Staff Report

Infill Housing Design Review Committee

File Number: 2-D-23-IH

Location: 0 Worth St. Parcel ID 81 K L 027

Plot Plan 0 Worth Street Parcel ID: 081KL0278

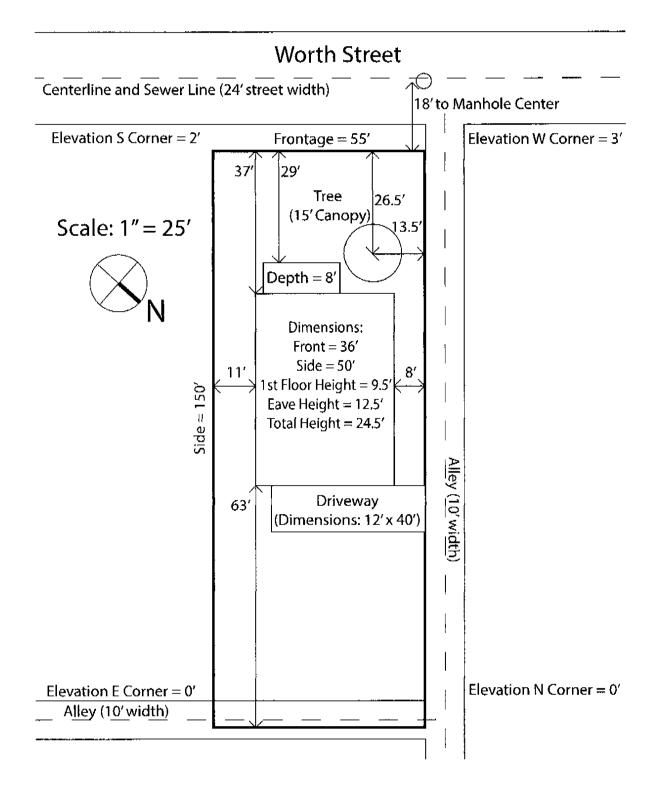
- 1. The house's main massing is proposed to be set 37' from the front property line, with an 8' deep front porch at 29'. The average front setback of the blockface is 21'. The house should be moved towards the front property line to align with the average front setback of the block. The final site plan should include a walkway from the front porch to the street.

- 3. The proposed parking meets Infill Housing design guidelines as being located behind the main house and accessible from the alley. Final modifications may be necessary to meet City Engineering standards and ensure a proper turn radius from the garages. Modifications to parking may be approved by staff, provided they meet the guidelines and do not affect the house's design.

- 9. The final site plan should include a native or naturalized shade tree in the front and rear yards.

FRONT ELEVATION (Worth Street)

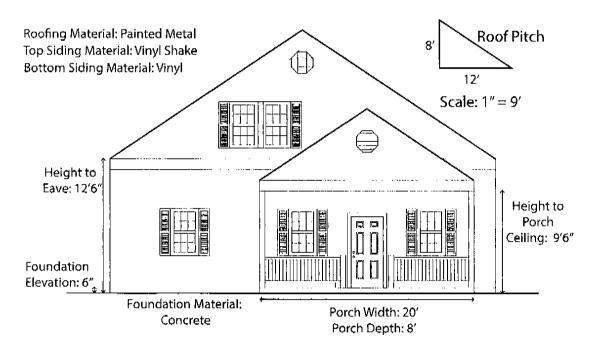
- 4. The 1.5-story, three-bay façade is similar in scale and width to the block and neighborhood. While most houses on the block are one story, a half-story in the upper gable field is not uncommon in the overall neighborhood. Guidelines recommend foundations be the same height as original houses in the neighborhood. The foundation height should be elevated to be compatible with surrounding historic houses.

- 5. The design includes a partial-width, front-gable roof porch on the right side of the façade. The front porch should use posts of at least 8 by 8 to be compatible with the context.

- 6. One-over-one, double-hung windows instead of multi-light windows with simulated muntins are typically considered to be more appropriate for the neighborhood. Infill Housing reviews also typically discourage shutters unless the shutters are appropriately scaled to the windows. The side elevations retain sufficient transparency. Revisions may be necessary to the off-center paired window in the gable field.

- 7. At 8/12, the roof pitch is compatible with the neighborhood context. Side elevation drawings indicate eave overhangs, though they're not visible on front and rear elevation drawings; final design should incorporate at least a 1' eave overhang on all sides. Infill guidelines do not recommend specific roofing materials, but recommend that darker shades be used. The foundation should be elevated and clad in stucco or brick veneer to be more compatible with the context.
